1997 - 1998, 2000 Corvette: Service Bulletin: Electronic Steering Column Lock May Refuse to Operate - DIC Service Message Displayed

Source: Chevrolet Dealer Service Bulletin

Number: 01-02-35-008

Subject: Electronic Steering Column Lock May Refuse to Operate - DIC Service Message Displayed (Update Column Lock Wiring, Install Revised Relay and/or Replace Electronic Column Lock)

ECL Disconnect: 1997, 1998 and 2000 Models with Automatic Transmission (Domestic)

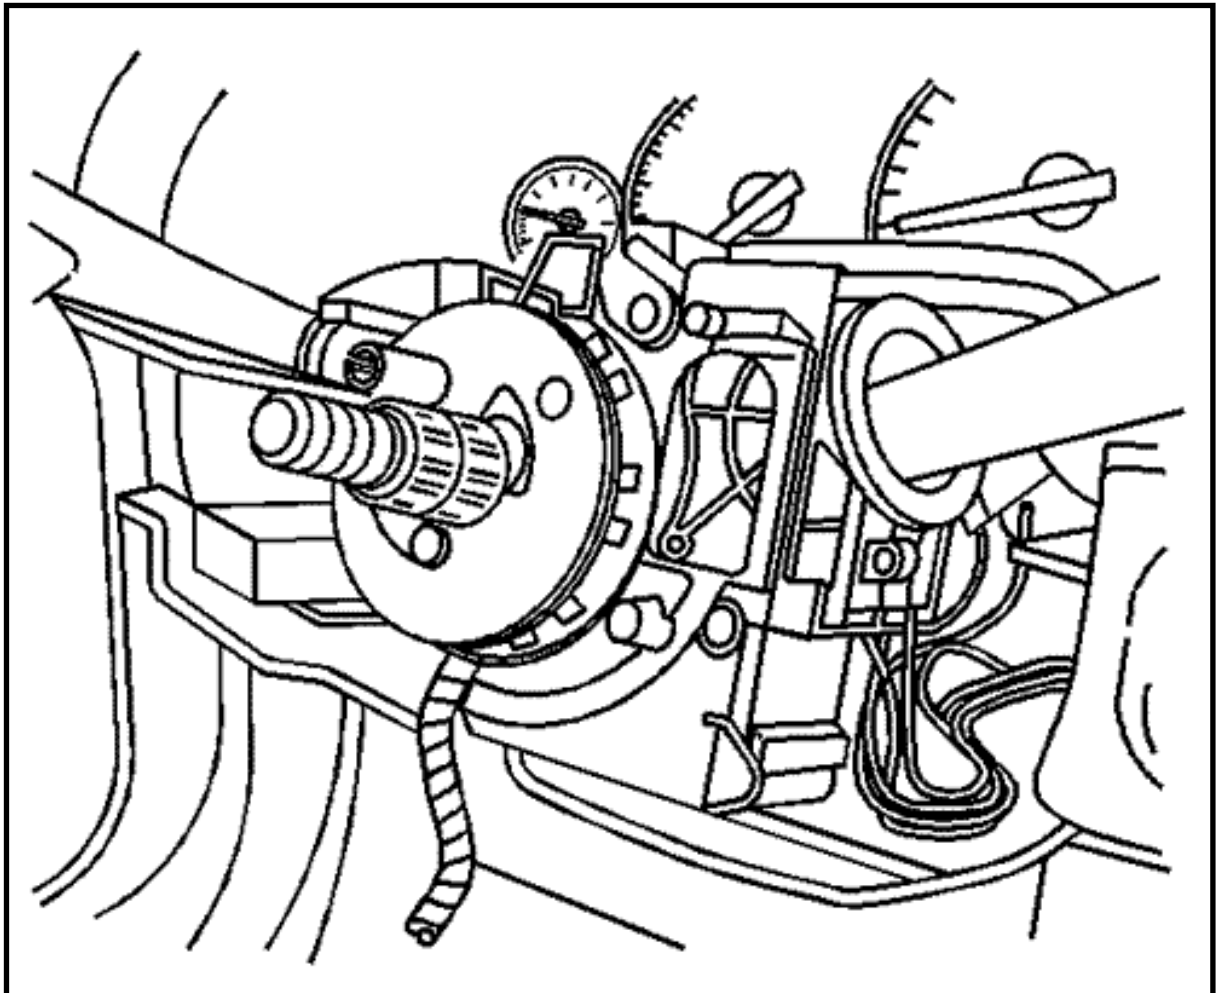
16. Route the new jumper wire and relay harness over the knee bolster (styrofoam and metal construction). The new relay (1) must be mounted to the left I/P brace with a zip tie as shown.

17. Install the new relay and jumper harness. Plug one end of the jumper harness into the connector on the I/P harness side. Plug the other end into the connector on the ECL side. The connectors on the jumper are specific and cannot be connected incorrectly. The connector becomes J165/P165.
18. Install the lower and upper steering column shrouds.
19. Install the wiper control stalk.
20. Install the tilt steering lever.
21. Install the steering wheel to the steering column.
22. Install a new steering wheel set nut, P/N 26056108. **Tighten**

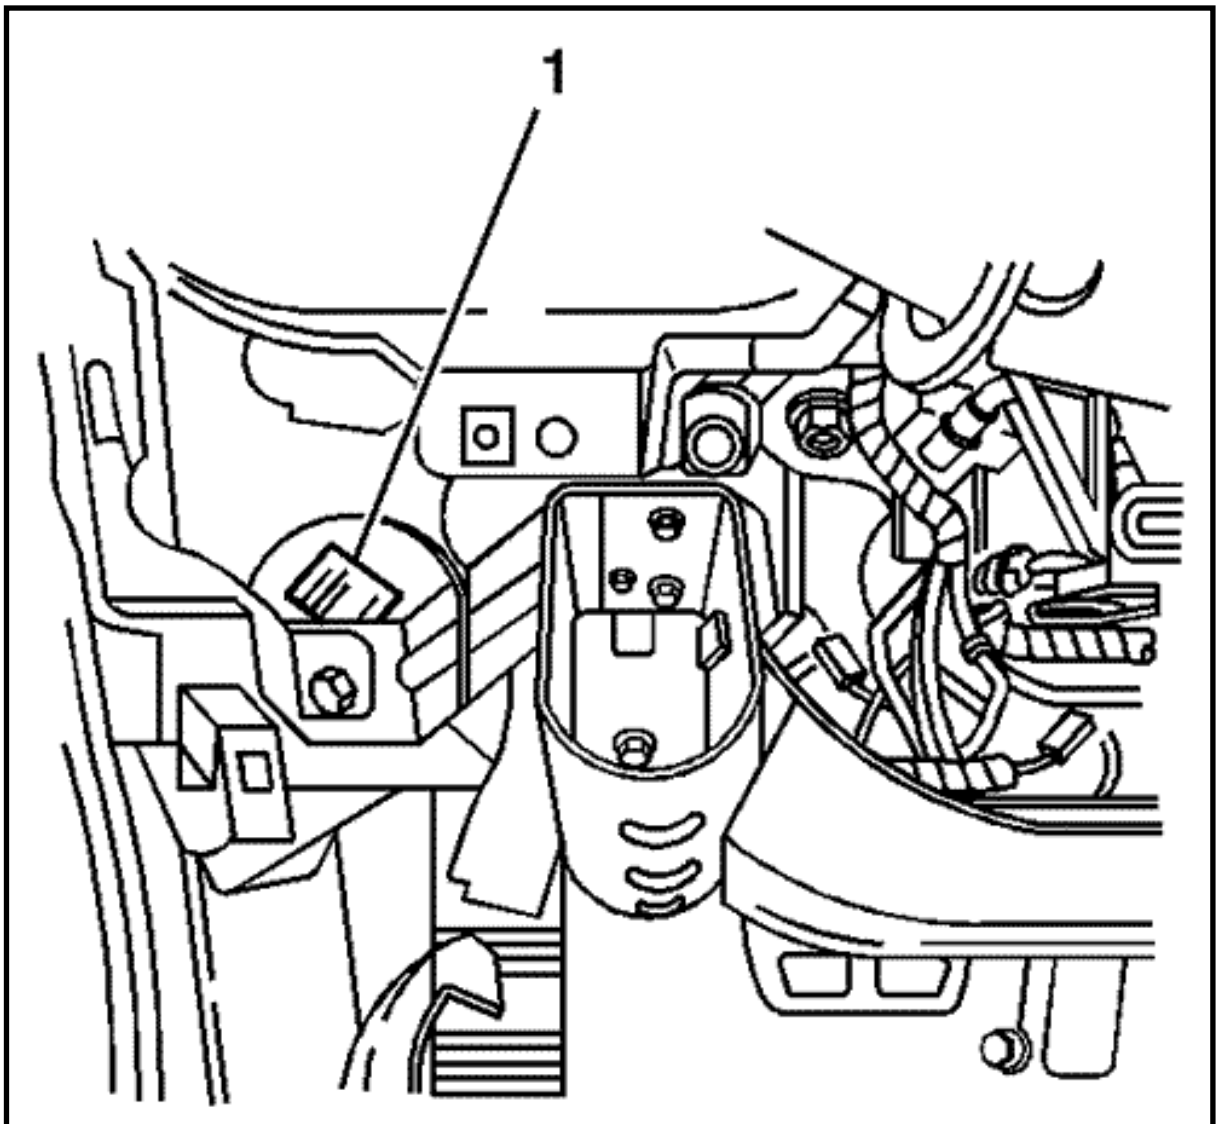
12. Remove and discard the Steering Column Lock/Cam Orientation plate

using the J 38364.

13. Install the included Cam Orientation Plate and secure with a new locking ring, using J 42137 and J 38364 as shown.
14. Install the SIR coil and secure with snap ring.
15. Disconnect the connector from the ECL (located on the right lower side of the steering column) to the I/P main harness.

FIGURE 1997 and 1998 (early) Manual (U.S. & Canada and All Export (Manual & Auto)(c)

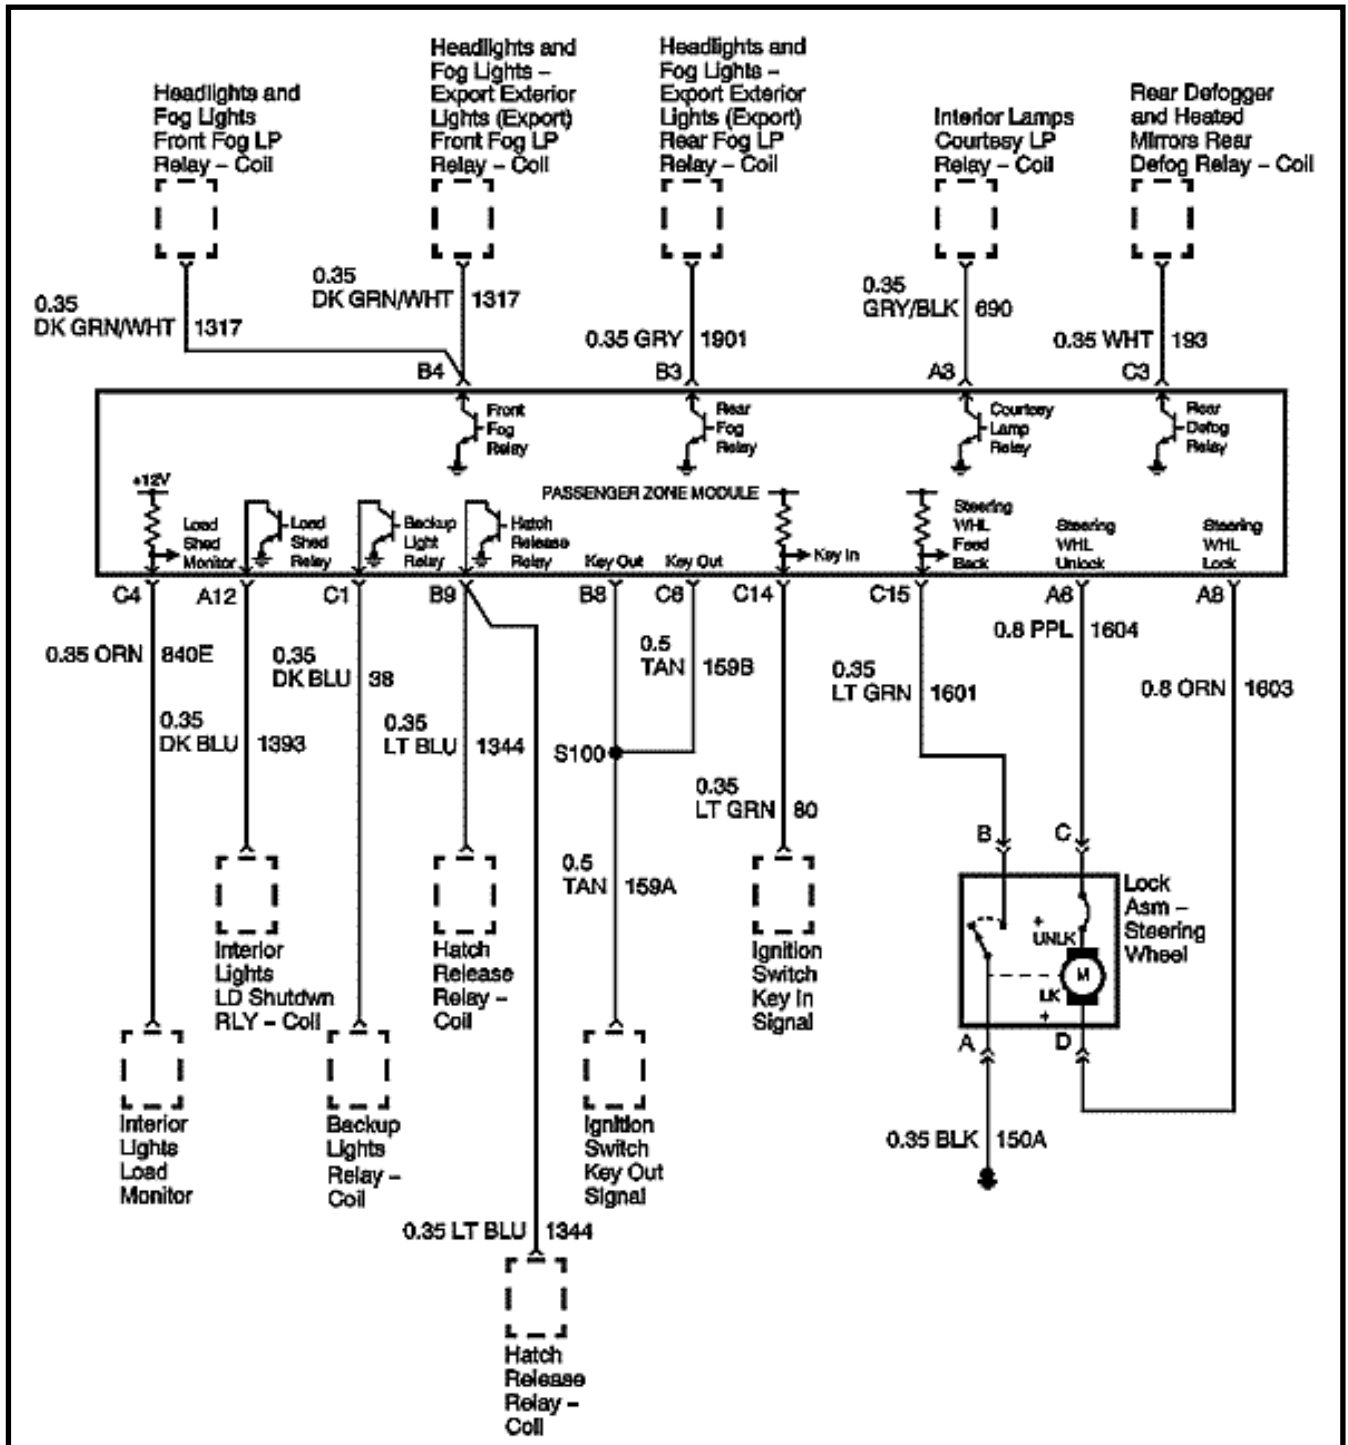
- **In order to complete the wiring upgrades listed in the section, you will need to order P/N 88952428, Wire Kit, Strg Wheel Theft Dtrnt.**
- **You may use the included schematics to aid in verifying the installation of the new relay and jumper wire.**

FIGURE 1997 and 1998 (early) Automatic (U.S. & Canada)(c)

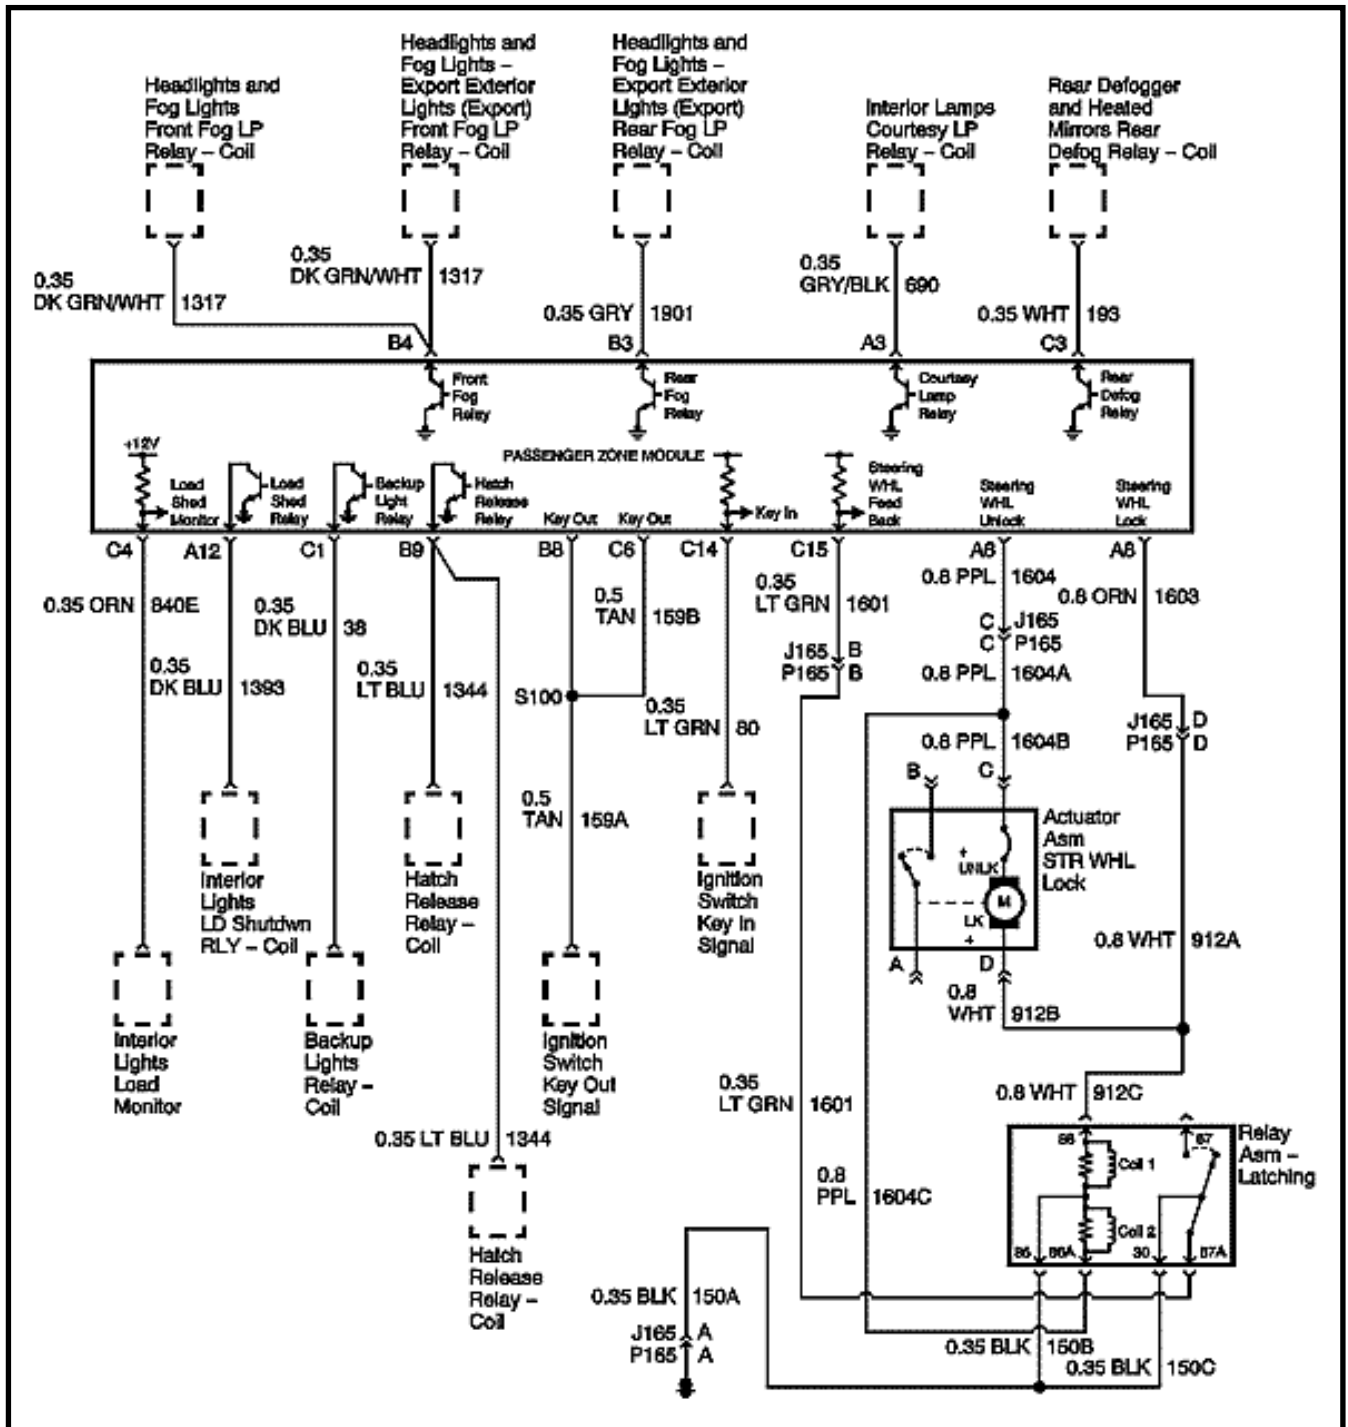
- **When removing the driver's side knee bolster trim panel as described below, care must be taken not to damage the console trim plate as the knee bolster trim panel tucks in behind the console trim plate.**
- **Revised schematics are included to aid and/or verify the proper installation of the service kit.**

FIGURE 2000 (late) Manual and All Export (c)

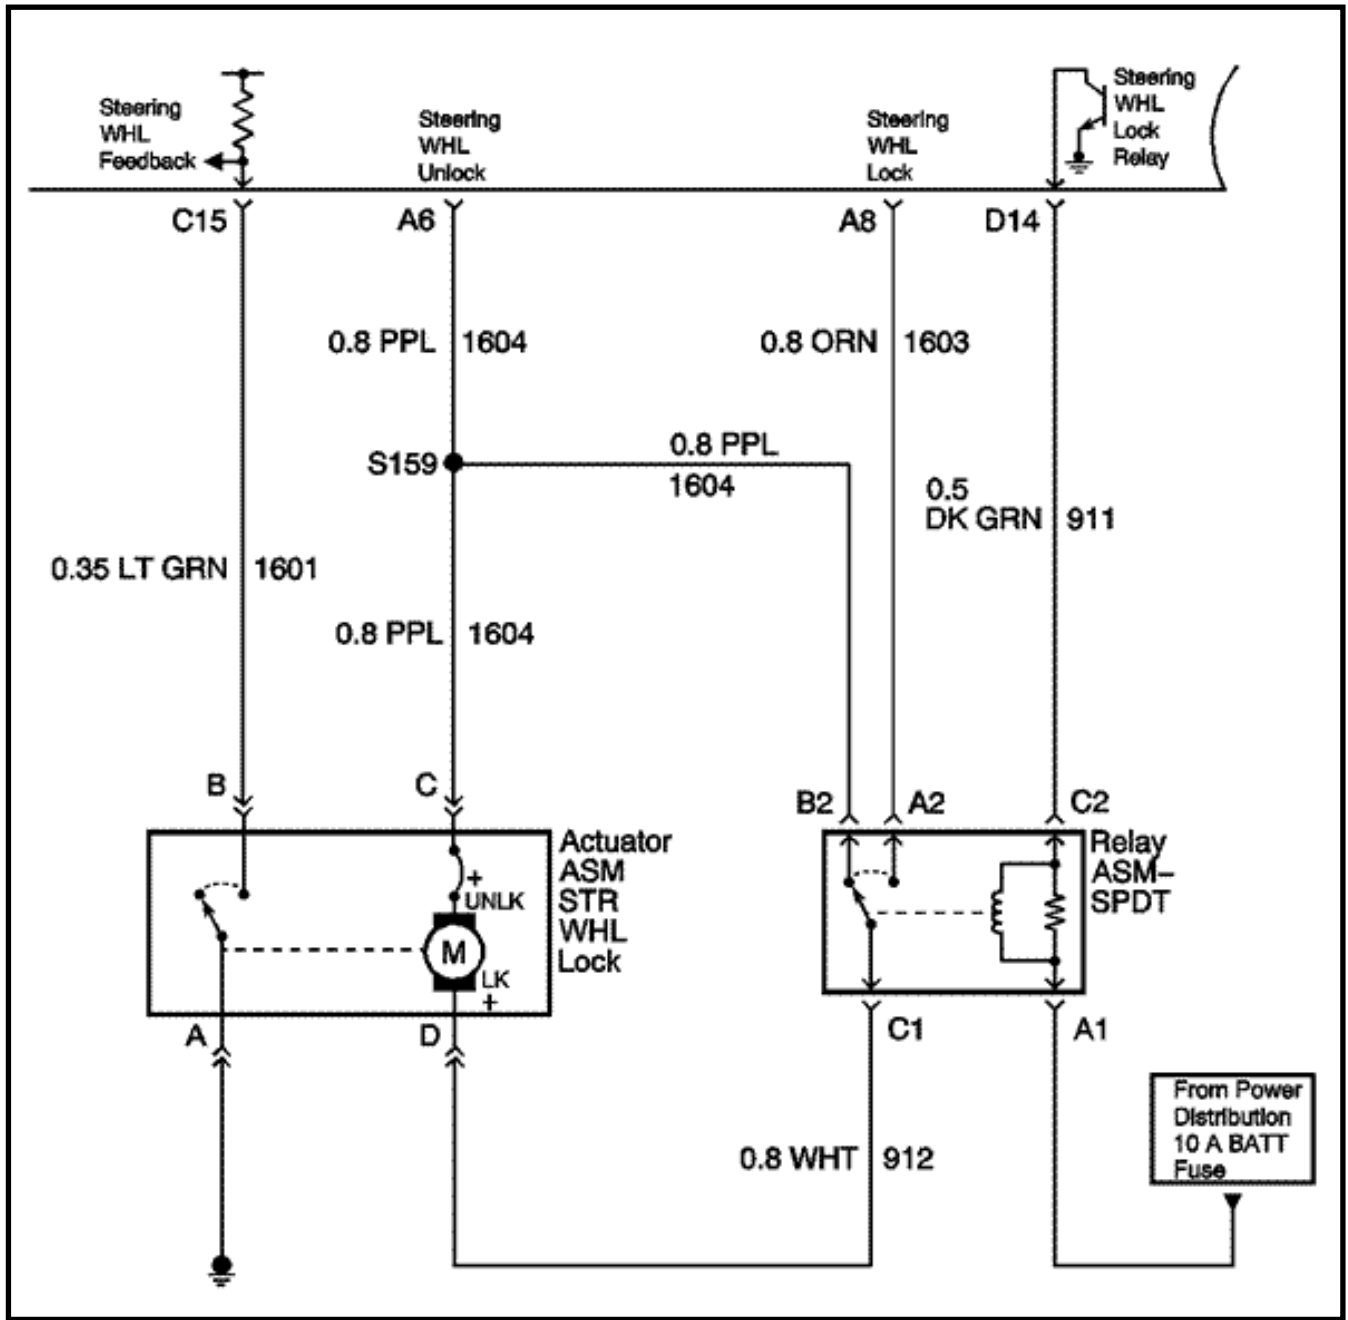
9. Remove the ECL relay harness from the backside of the relay assembly.
10. Remove the relay.
11. Remove the orange wire from position C1 on the ECL relay connector.

12. Remove the white wire from position A2 on the ECL relay connector.
13. Swap the two terminal positions and re-insert, orange wire to A2 and white wire to C1.

14. Add the new purple wire from the jumper to terminal position B2.
15. Install the new single pole, double throw relay.
16. Install the Green 16-way connector to the BCM.
